HISTORIC PRESERVATION COMMISSION

ALTERATION TO A HISTORIC PROPERTY STAFF REPORT

Site: 22 Flint Street c.1857 Donohoe-Davis House
Case: HPC 2016.098 R1 Flint Street Local Historic District

Date of Application: ~~November 29, 2016~~ May 21, 2018
Legal Notice: *Rebuild porches using Trex® flooring*
Staff Recommendation: ~~Denial~~ Re-issue of Certificates of Appropriateness and Non-Applicability
Date of Public Hearing: ~~January 10, 2017~~ June 19, 2018

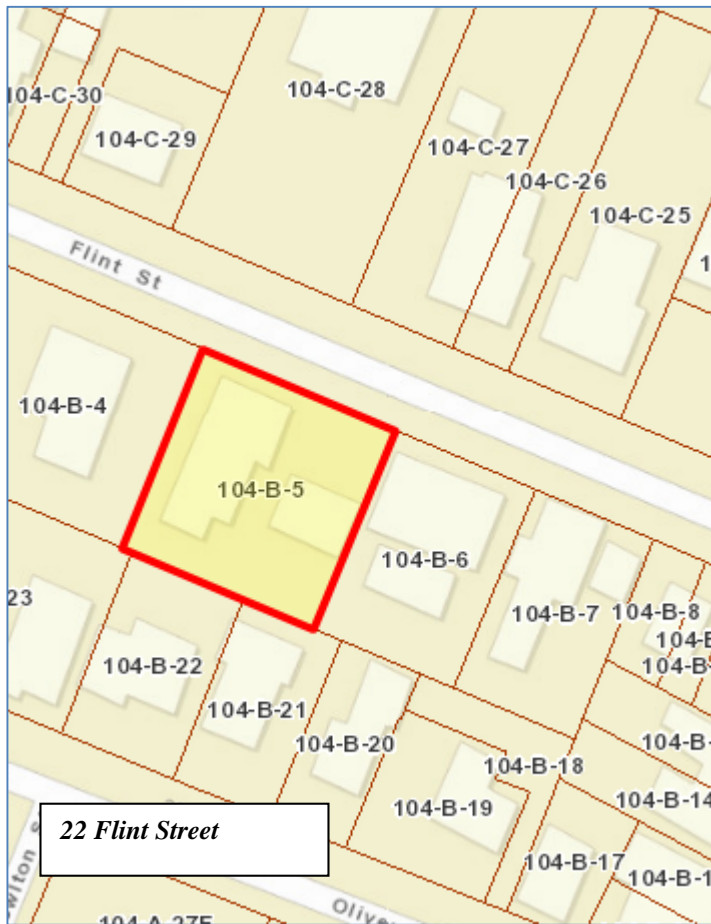
Trex® is not considered an appropriate material. The remaining alterations/repairs are in-keeping with HPC Guidelines with the exception of the original height of the railing on the ground floor. The Commission agreed in 2016 that edging of the porch with an appropriate material and painting the entire plane would make the alteration less obvious to passers-by and would be considered acceptable.

The main wrap-around porch was discussed in the Form B. The deteriorated posts will be reconstructed to match the existing. The porch appears to be 30" or less from the ground level which means the railings could be returned to their historic height. See detail showing existing rail with original post next to the front door. The second floor porch is not original to the building. The proposed alteration to the porch would bring it back to an earlier condition as can be seen in the photos below.

- ~~9-11.~~ The railing height shall be returned to the original height as seen where the porch meets the edge of the house. (C/A)
- ~~10-12.~~ The porch skirt shall be made of vertical wood lattice. (C/NA)
